PLANNING BOARD REPORT PORTLAND, MAINE

Parris Terraces, 60 Parris Street
Level III Subdivision and Conditional Use Review
2017-287
Horton LLC

Submitted to: Portland Planning Board Date: March 23, 2018 Public Hearing Date: March 27, 2018	Prepared by: Nell Donaldson, Planner CBLs: 33-A-13 Project #: 2017-287
------------------------------------------------------------------------------------------------------	------------------------------------------------------------------------------

Figure 4: Proposed driveway

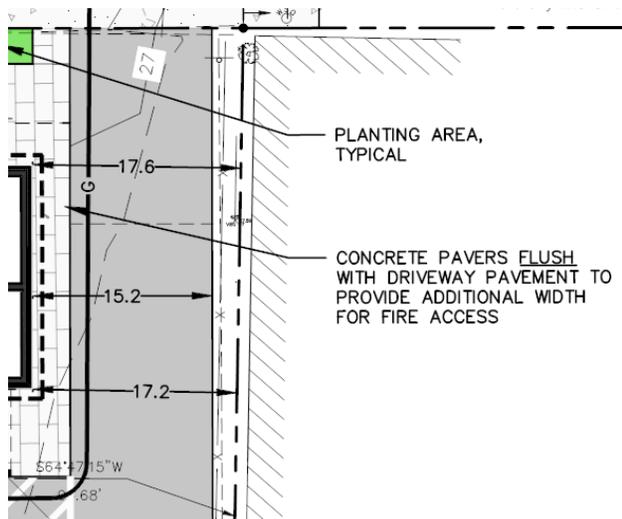
In response to staff comments, the applicant has increased the driveway width at the southern end of the site to 15.2’. The northerly edge of this driveway is proposed with flush concrete pavers as a means of differentiating a pedestrian way along the edge of the building.

As a driveway with two-way access of less than 20 feet in width, a waiver is required. Fire has reviewed the plan and indicated that they are satisfied with the driveway layout (*Attachment 4*).

The plans have been revised to provide a 15.2 foot wide driveway entrance that will function as a shared driveway (pedestrian facility will be flush). As noted previously, the project site would be expected to generate very low traffic volumes and during peak time periods traffic will primarily either be entering the site (returning home) or exiting the site (leaving home). During the morning peak hour, approximately 8 vehicles would be expected to exit the site and 2 vehicles will enter the site. This corresponds to one vehicle every 6 minutes. During the afternoon peak hour, about 8 vehicles would be expected to enter the site and 4 vehicles exit. This corresponds to one vehicle every 5 minutes. Given vehicle movement infrequency, the likelihood that trip levels will be less given the urban location, and low traffic volumes on Parris Street, I support a waiver from the minimum driveway width standard of 20 feet.

The proposed driveway does not meet City standards as it relates to driveway separation. Given that the non-conformity is an existing condition, the abutting driveway is to a single vehicle driveway, and traffic volumes are relatively low on Parris Street, I support a waiver from the City's Technical standards.

Figures 5 & 6: Rendering from the northeast; east elevation

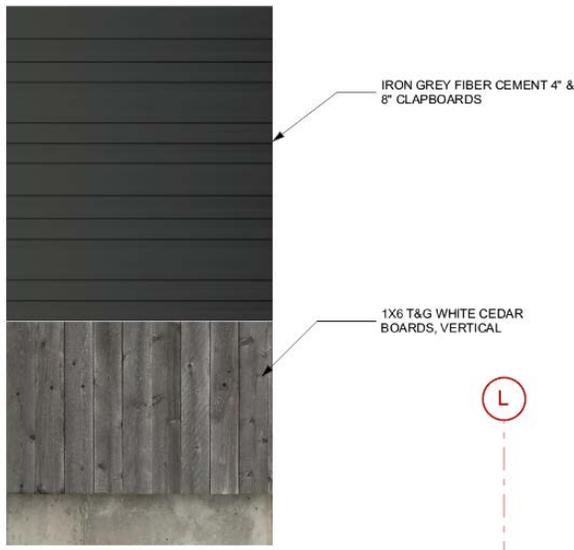
*Standard (1) c. Building Entrances – Main building entrance faces and is directly accessible from the street. **For legibility of primary entrance, staff prefer the trash room door be relocated to the side of the building to not compete with residential entrance.** To respond to the concerns about emphasis of the main entry, the design now includes a material and color change – staff support this direction. **However, how will the material transition from the vertical siding? Is more than one color really needed to achieve the effect? Could any more be done to add emphasis to this entry – canopy or similar gesture?***

*Standard (1) g. Building Materials – Primary material was revised to fiber cement clapboard with vertical cedar board. Staff support the scale, orientation, and type of materials as proposed, however, **we question whether natural cedar finish on the ground floor is contextually appropriate. Though natural cedar has been approved for accent materials like fences and railings, as a prominent siding material, it is more rural in character. Planning Board also asked to better understand how that material will age/patina.***

scale, and visual interest to the buildings, even if in a vernacular way. This design was revised to use clapboard with a varying reveal on the upper floors, cedar balconies, and vertical board with natural cedar. Staff finds these changes to be responsive to review comment and gives some articulation and texture to the building in a way that is contextual. **There remains some question as to whether natural cedar is a contextually appropriate siding material, especially on the ground floor.**

attempted to de-emphasize the trash room door by coordinating its color with the surrounding siding; emphasize the entrance with lighting, decorative signage, and color panels; provide an accurate depiction of the cedar siding as it ages; and identify other projects in which cedar has been used, including 75 York Street. A final design review based on the most current elevations and rendering has been suggested as a condition of approval.
